Notice of Addendum #1

ELSA Vehicle Storage Building

RVE Project: 1102-M-026

Township of Lawrence, Mercer County, New Jersey

FIRE WALL PILASTER DETAIL

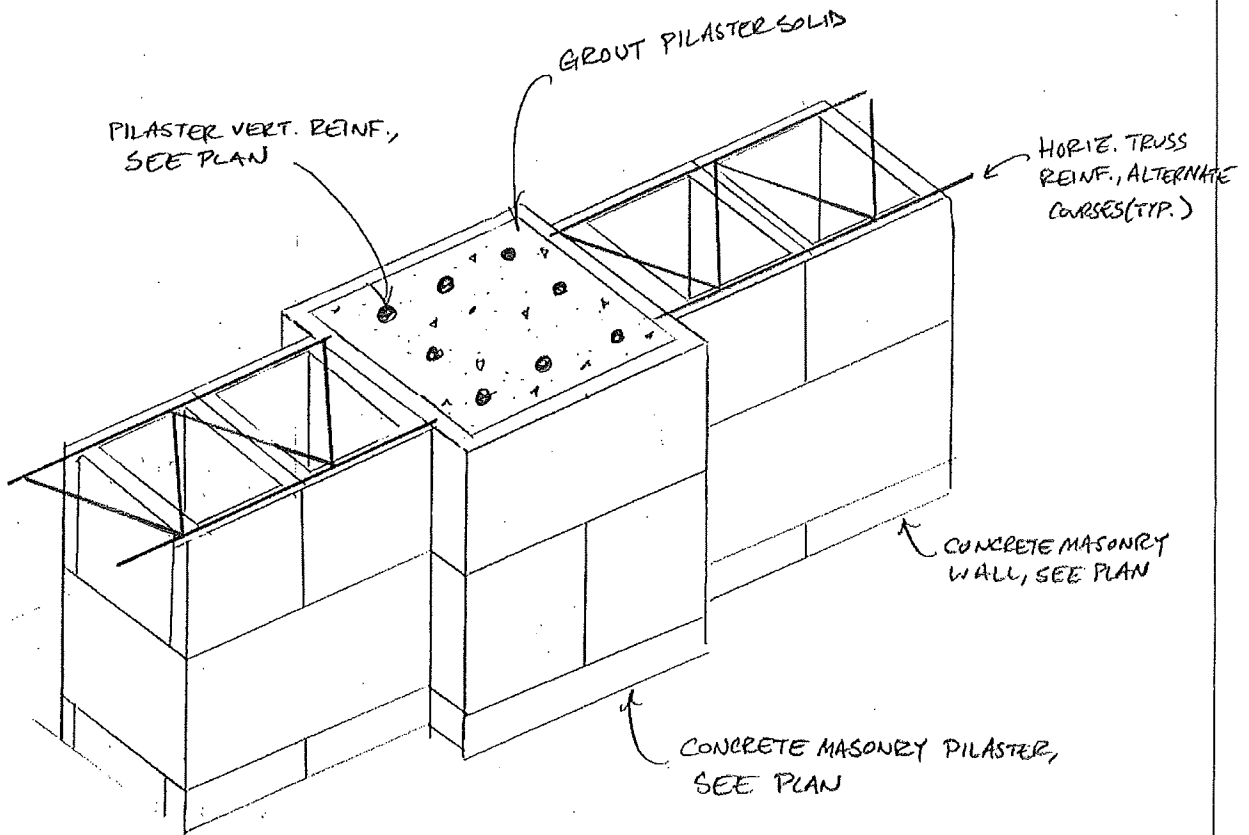
- 2.2 Please provide the detail for 16" x 16" Masonry Pilaster identified on drawing S-2.

*RVE Response: A detail entitled "Fire Wall Pilaster Detail" has been provided for the masonry pilaster and is attached as part of this addendum.*
